SUBDIVISION REVIEW SHEET

CASE NO.: C8J-2021-0163

SUBDIVISION NAME: Easton Park Section 4B East Preliminary Plan

CITY OF AUSTIN – TRAVIS COUNTY – SINGLE SUBDIVISION OFFICE
SUBDIVISION APPLICATION – MASTER COMMENT REPORT

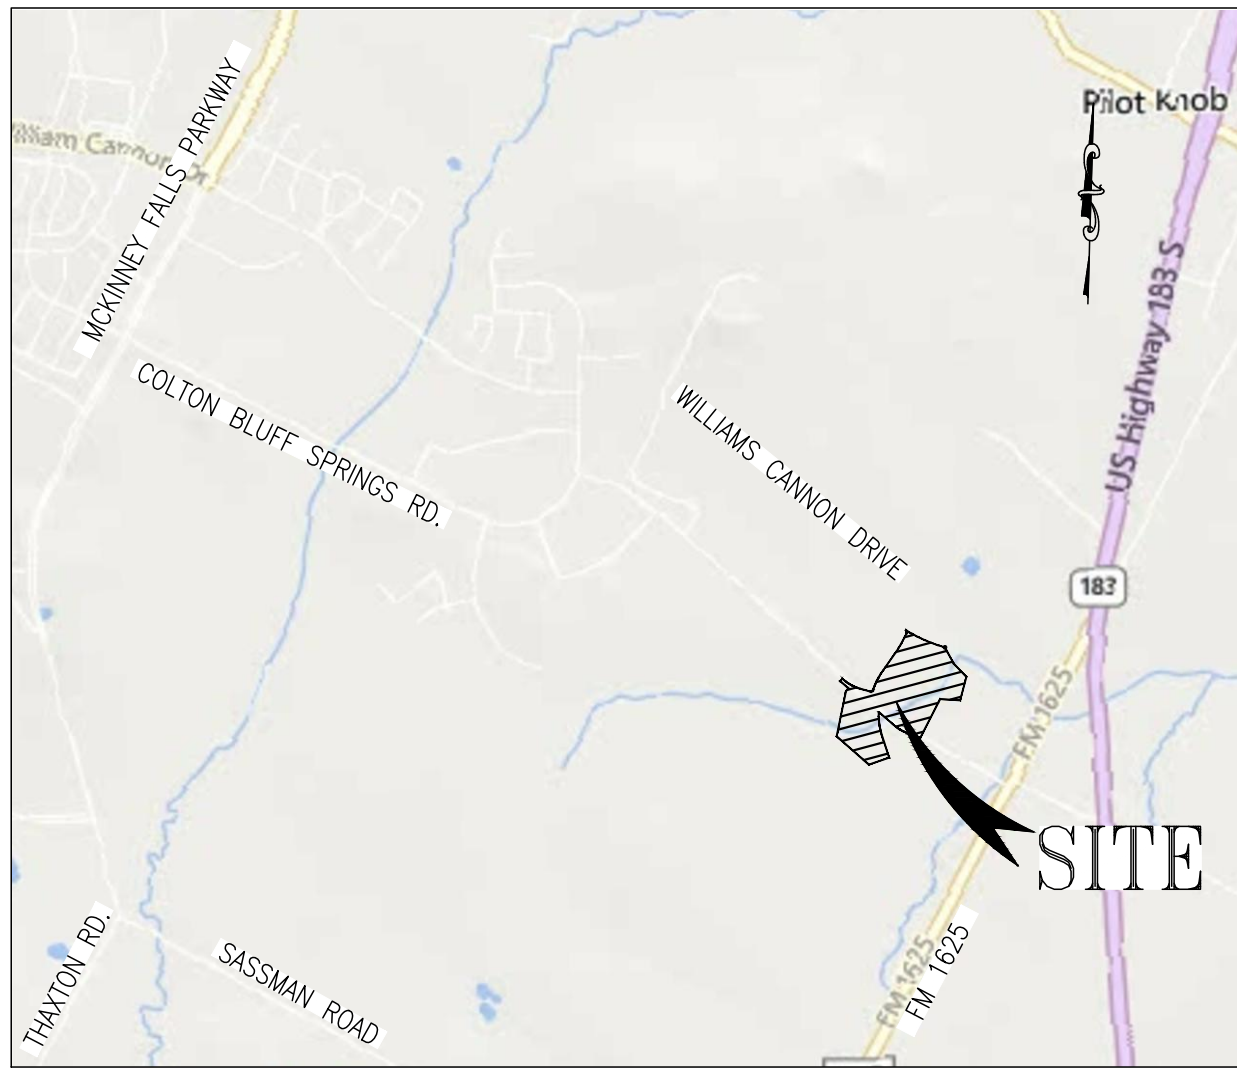
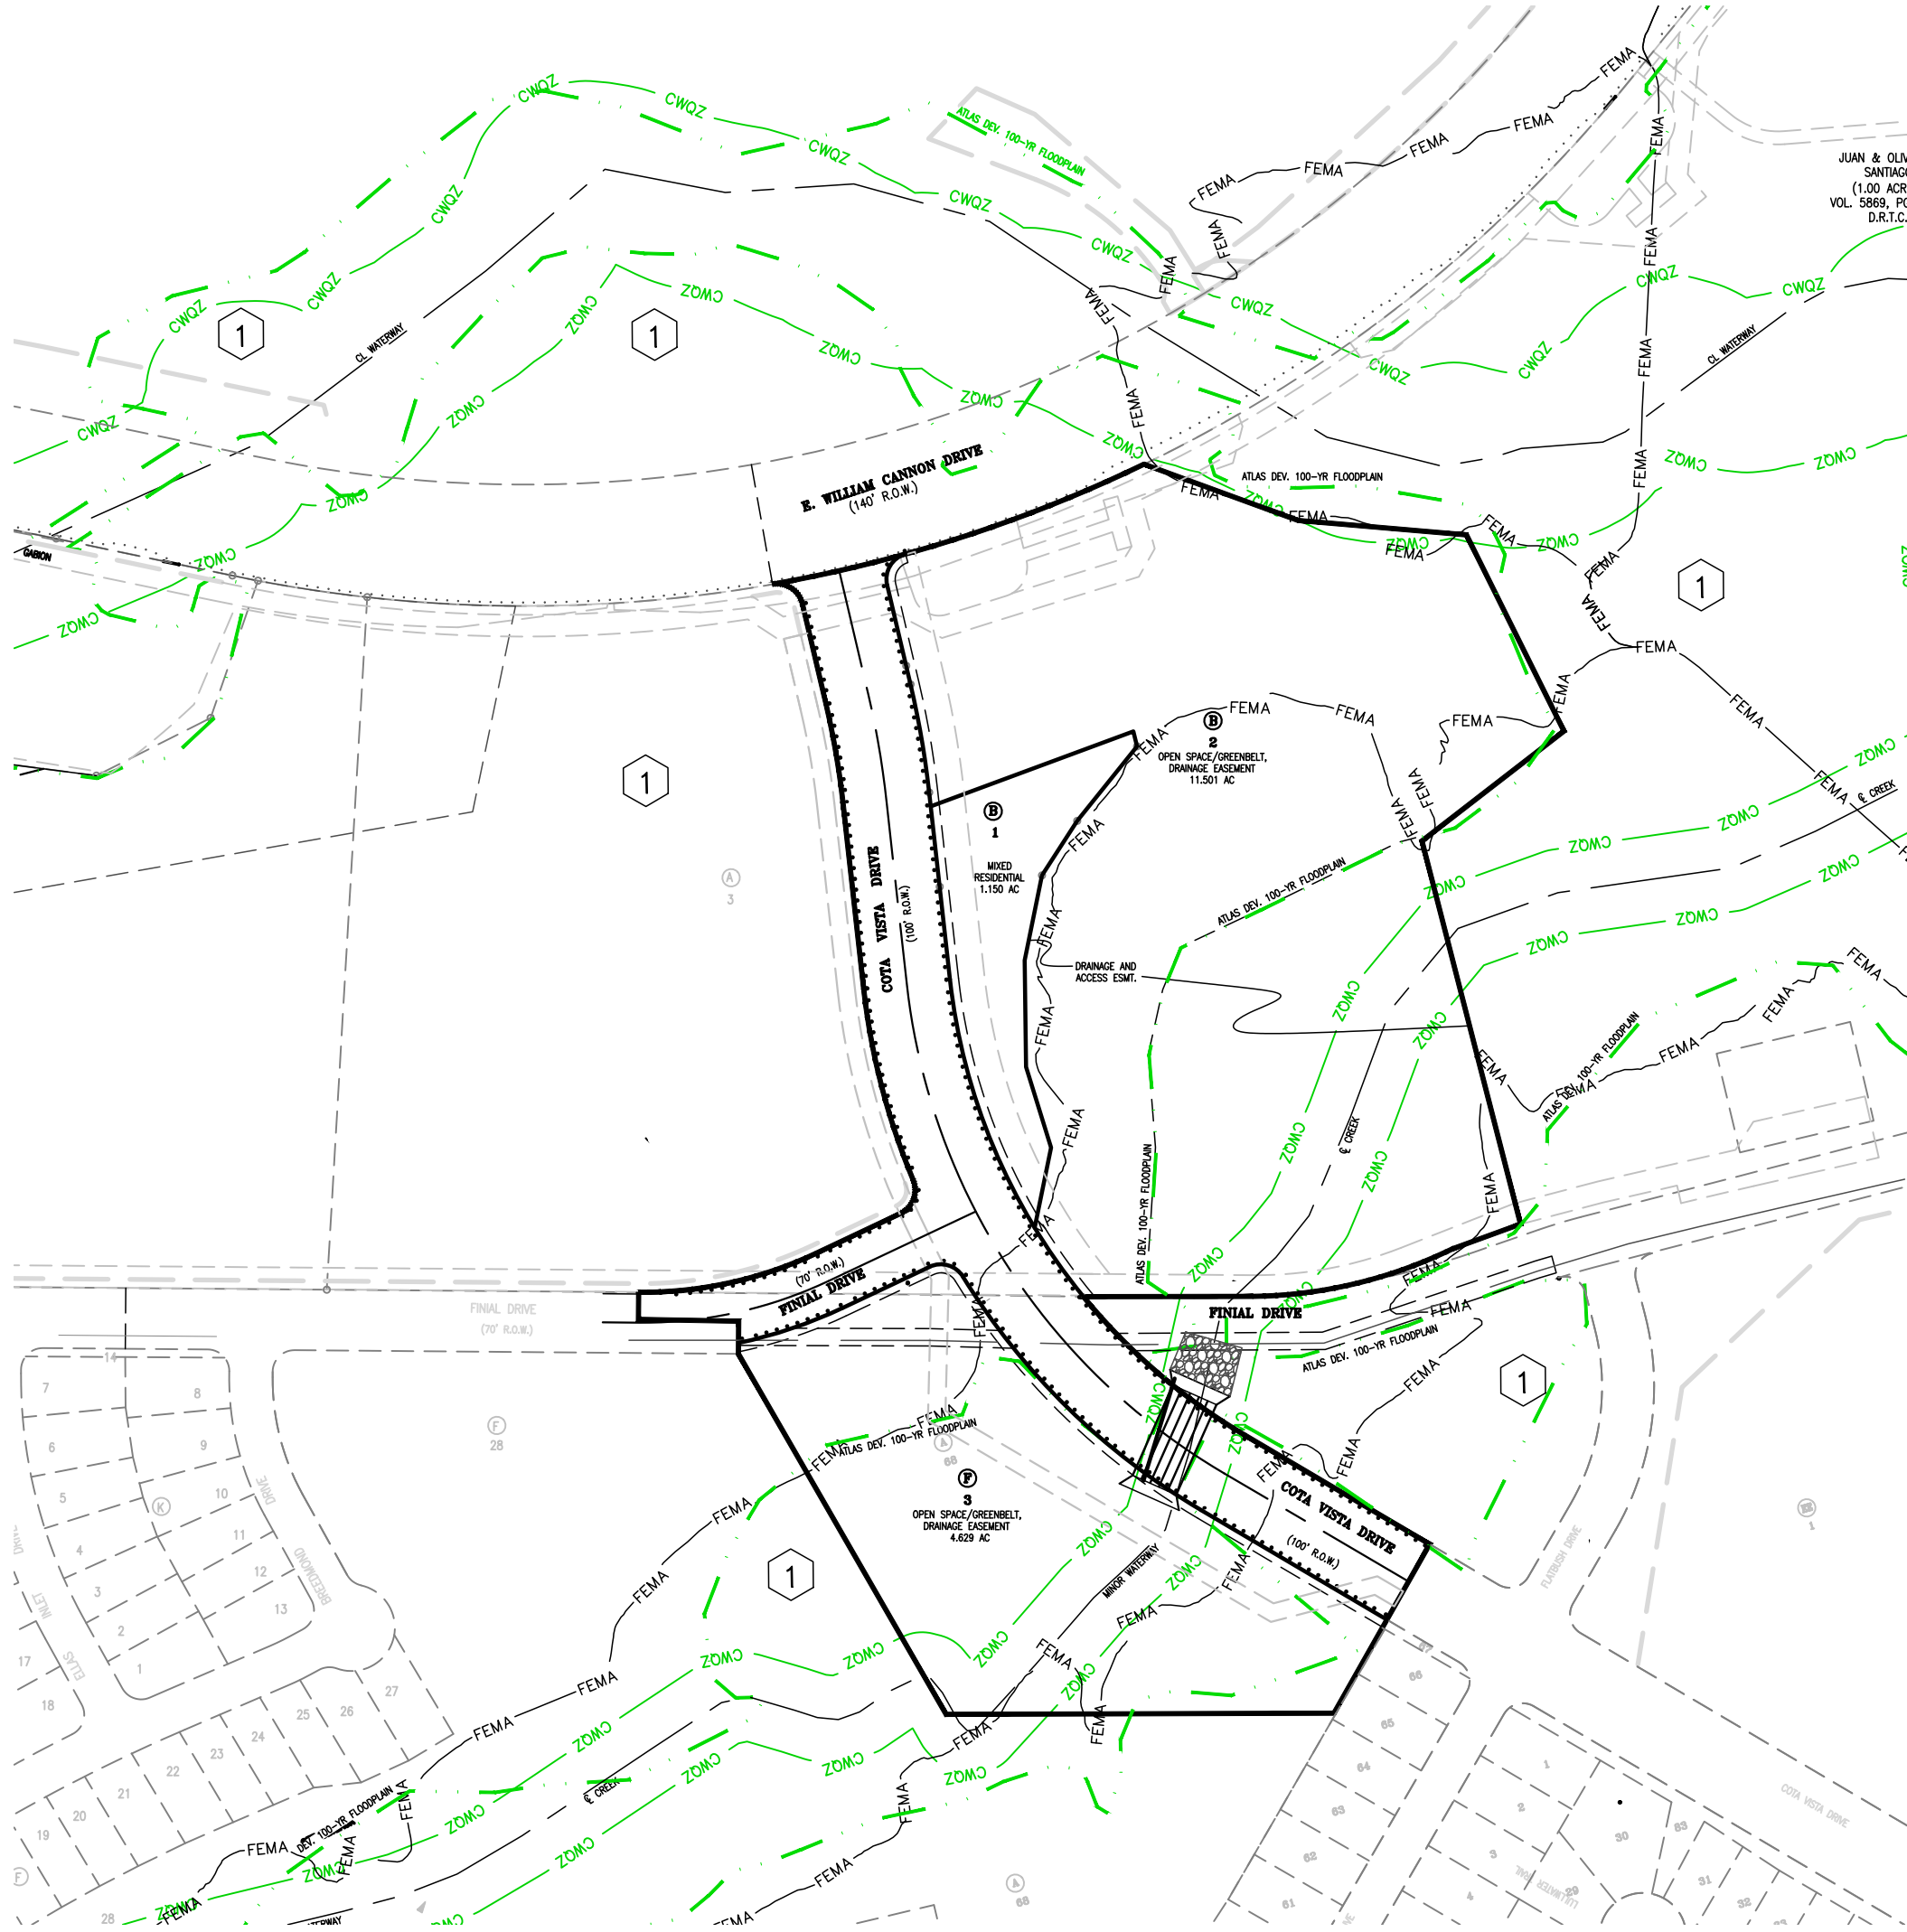
1. Add "drainage" to the open space/greenbelt lots on the table on page 1. 30-1-113
2. FYI - The proposed abandonment of Final by Court will need to be coordinated with the final plat.
3. FYI - An Educational Impact Statement may be required. Refer to Exhibit IV of the application. It is the responsibility of the applicant to submit the EIS to the appropriate school district. 25-1-83 or 30-1-113
